Record of Decision

Test Reactor Area Perched Water System

Operable Unit 2-12

Idaho National Engineering Laboratory
Idaho Falls, Idaho

Figure 4. Configuration of the deep perched groundwater at the Test Reactor Area, March 21, 1991.

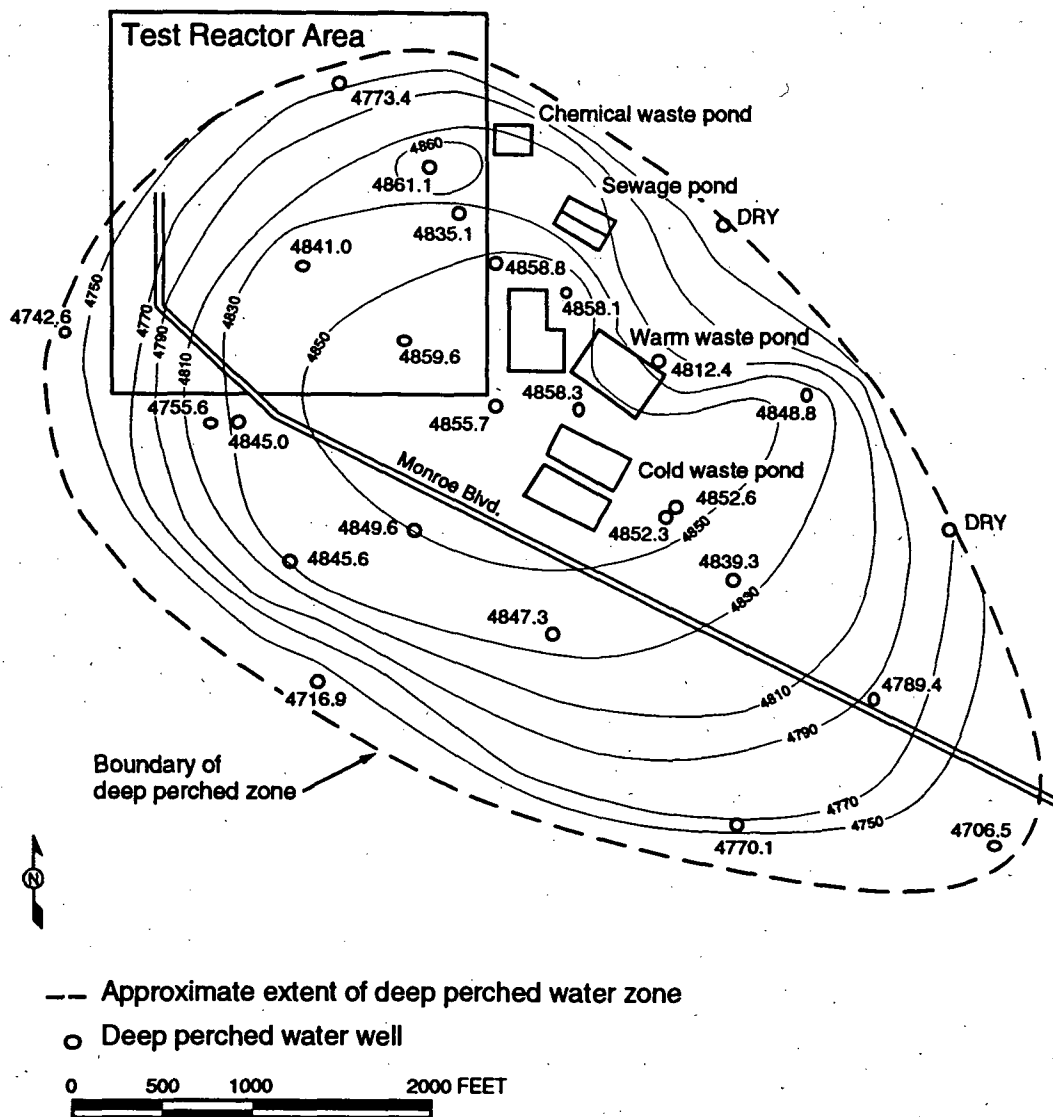
- 1. Comment:** Commenters question DOE's characterization of the size of the contaminated perched water zone. As noted in a comment on the Remedial Investigation Report from IDHW, the wells along the northeast margin of the Perched Water System are too deep to adequately represent water levels. (W1-4, W8-2, T2-4)

Response: This issue was identified in IDHW's January 1992 comments on the Remedial Investigation Report. The concern was resolved as follows: The size of the deep perched zone is estimated from water-level measurements in deep perched zone wells. These wells measure the thickness of the deep Perched Water System above the 150-foot interbed (150 feet below land surface) upon which the water is perched. It is true that the deep perched water could extend farther to the northeast than is illustrated in the figures in the Remedial Investigation Report. Although the lateral extent of the deep perched zone to the northeast is not fully constrained by dry perched wells which would indicate the extent of perched water, water levels in wells such as PW-7, USGS-72, USGS-74, USGS-66, and USGS-71, indicate that the perched water zone tapers laterally, allowing a reasonable approximation of the edge and, therefore, the size of the perched zone. Model results are based on a perched water body with no confining boundary conditions, thus simulating a more laterally extensive system (worst-case) than is observed. Therefore, defining the exact edge of the entire Perched Water System is not crucial for modeling the system.
